TR-2009-05

Site Visit to Horseshoe Dam Outlet Works and Spillways, AZ

Subject: Site Visit to Horseshoe Dam Outlet Works and Spillways, AZ

Figure 4. – Horseshoe Dam Service Spillway – Isometric View of Spillway Gate Control System.

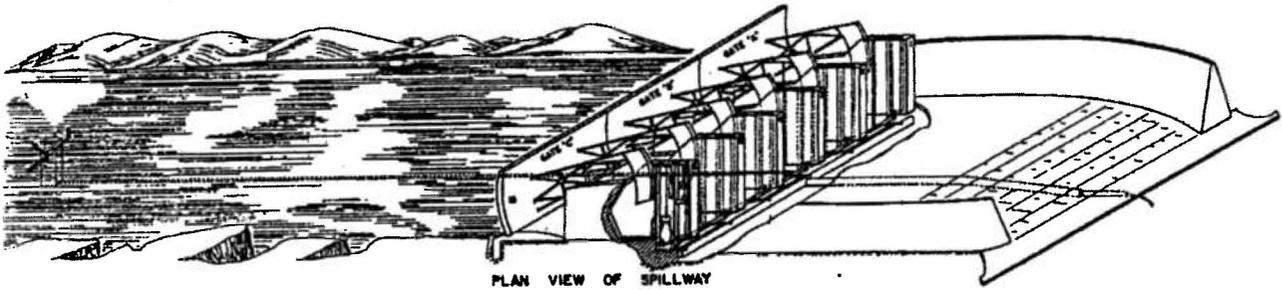
As an explanation about why gate No. 3 does not bind under balanced conditions, the following is offered: The steel tank counterweight (noted as part #11 in Figure 4) is neutrally buoyant during automatic operation, and partly buoyant when operated by hoist with water loading against the gates (and counterweight chamber partially filled). When operated in dry conditions, the counterweight experiences no buoyant force and thus exerts maximum force to close the gate. This helps to explain why binding is not observed when the gate is operated under balanced conditions (even large binding forces can potentially be overcome by the full force of the counterweight).

Figure 7. – Horseshoe Dam Outlet Works Air Vent.

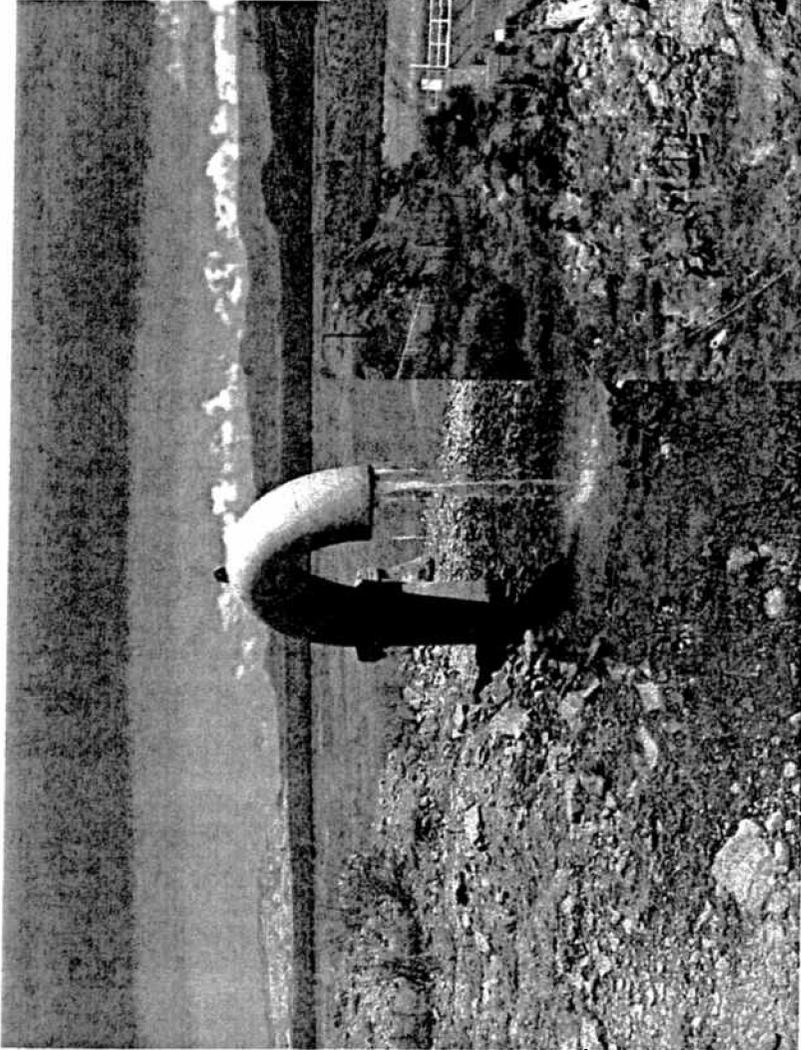
- **Air Vent.** – As has been well documented in past inspections, there is significant release of air (and associated water) from the air vent (see Figure 7) located just downstream from the horizontal elbow in the tunnel. Air and water releases are greatest at intermediate gate openings (200 to 625 ft³/s referenced in past reports). Baffles were added to the vent pipe in 2004 and 2005 and have helped to reduce the volume of water being discharged. The observed air releases are consistent with the known performance of cylinder gates at partial openings, where they typically entrain air, which is drawn down through the center of the hollow cylinder. As a result, cylinder gates are not typically used as control (regulating) gates. At most Reclamation dams with cylinder gates, they are used as guard gates set either fully closed or fully open. The greatest problem with the current situation at the air vent is the intermittent water discharge, which has the potential to cause erosion and unsafe walking conditions along the path leading to the outlet works control tower. One modification that might further reduce the volume of water released would be to add an enlarged section of pipe at the top of the riser, between the riser and the gooseneck pipe section.

- Reduce air vent surging. - The discharge of water at the air vent pipe might be further reduced by adding an enlarged section of pipe at the top of the riser, between the riser and the gooseneck pipe. Slugs of water would expand in the larger pipe, allowing the air to bypass them, and the water could then fall back into the riser.

Figure 8. – Horseshoe Dam Outlet Works Intake Tower – View from embankment dam crest.

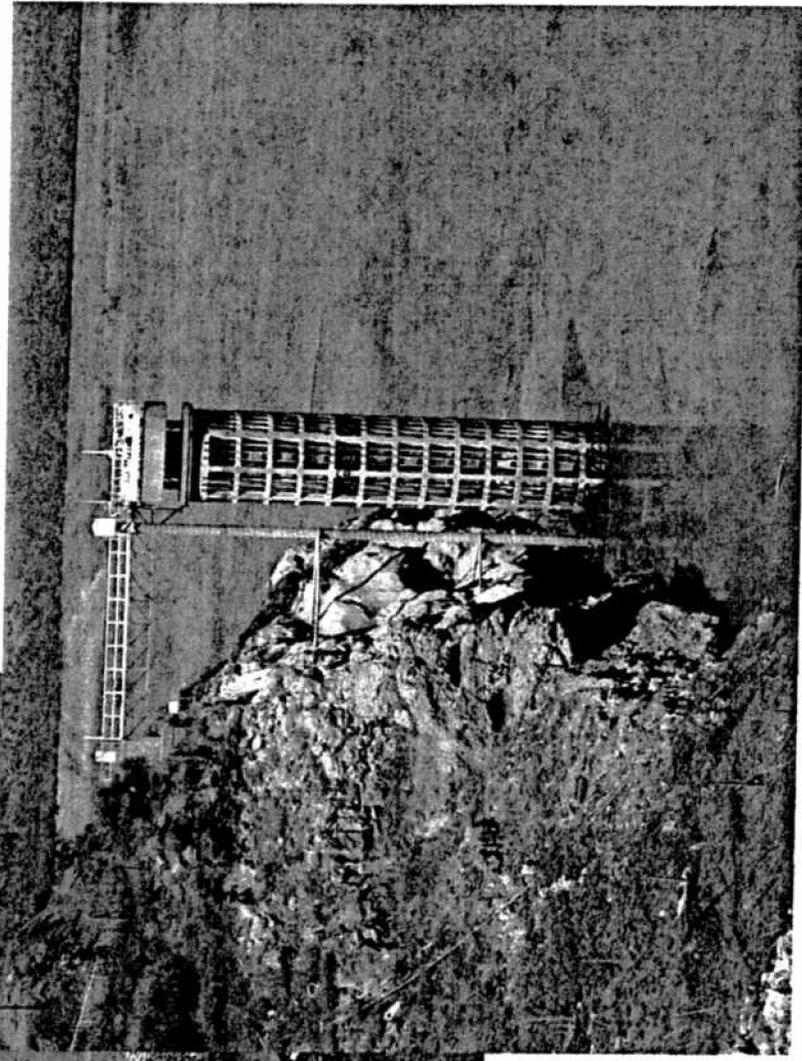
- **Intake Tower.** – Areas of focus for the inspection of the intake tower (see Figure 8) included:
 - The interior of the cylinder gate was inspected via a bosons' chair. Gary Rood, Rodney Tang and Roger Baker participated in this effort. Overall condition of the cylinder gate was satisfactory, but there was some evidence of corrosion. Specifically, three corrosion conditions were noted along the interior of the gate. Area No. 1: Between approximately elevation 1910 and elevation 1955, some rusting was noted, but overall condition is good (see Figure 11); Area No. 2: Between approximately elevation 1955 and elevation 2000, some rust under coating and some swelling from rusting was noted (see Figure 12); and Area No. 3: Between approximately elevation 2000 to top of gate, there were minor and isolated loss of coating with little rusting underneath.(see Figure 13). All the connection bolts and nuts that were observed were still in very good condition. None of the rusting condition would prevent the gate from being used, but corrosion protection and re-coating would not be out of the question if use of the gate is planned for the long-term (next 50 years).

Figure 10. – Horseshoe Outlet Works Tunnel Portal Nozzle (Drawing B-159-1) – Channel formed in crown of steel nozzle, installed in 1958.

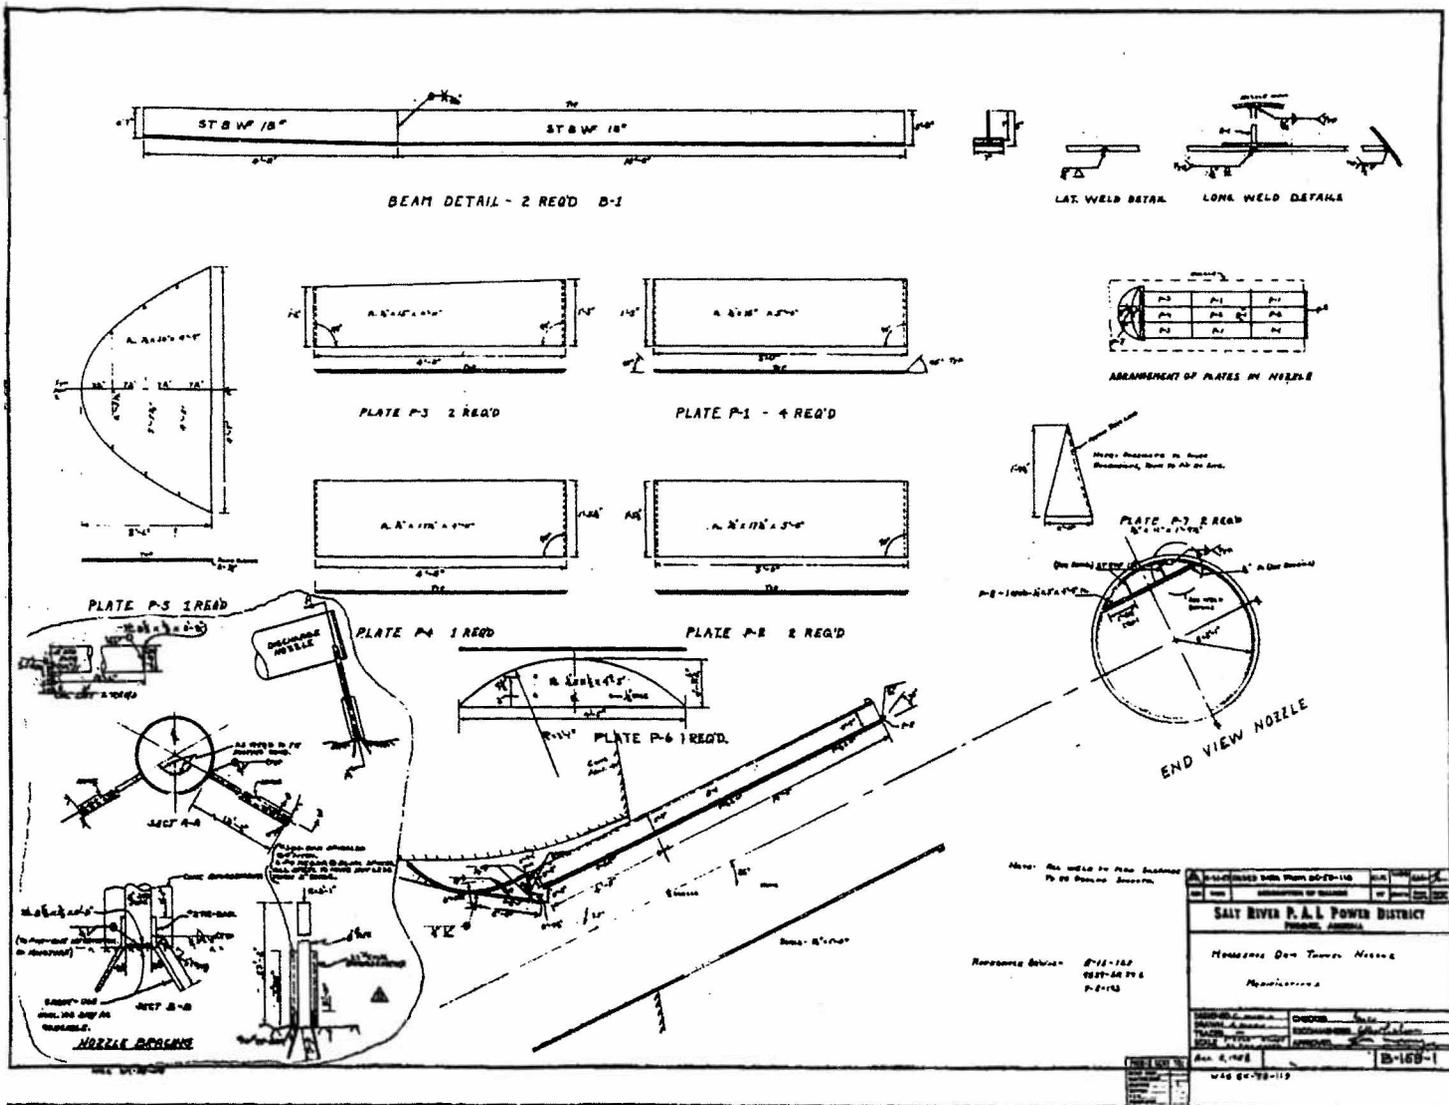
- Based on drawing B-159-1, see (Figure 10), an air vent or inlet channel constructed from steel plate was added in 1958. The plates form a channel in the crown of the steel nozzle, which appears to provide either air admission or release. At low flows, such as those that were observed, the channel seems to allow a controlled escape of air that has accumulated at the tunnel crown just upstream from the nozzle (the crown of the conduit drops at the upstream end of the nozzle as a result of the 1947 modification, thus blocking downstream air movement along the crown of the pipe). Without this modification, it seems likely that air would be released in a more irregular manner and may significantly disrupt the jet issuing from the nozzle. A deflector plate at the upstream end of this channel suggests a second possible purpose, which is the admission of air near the throat (upstream end) of the nozzle to produce a free surface in the flow through the nozzle extension. The deflector plate appears to have been configured to create a local low-pressure zone that would draw air into the conduit. This may improve the flow out of the nozzle at higher flow rates than those observed. It remains unresolved which of these two purposes the air channel serves; it may even serve both purposes.
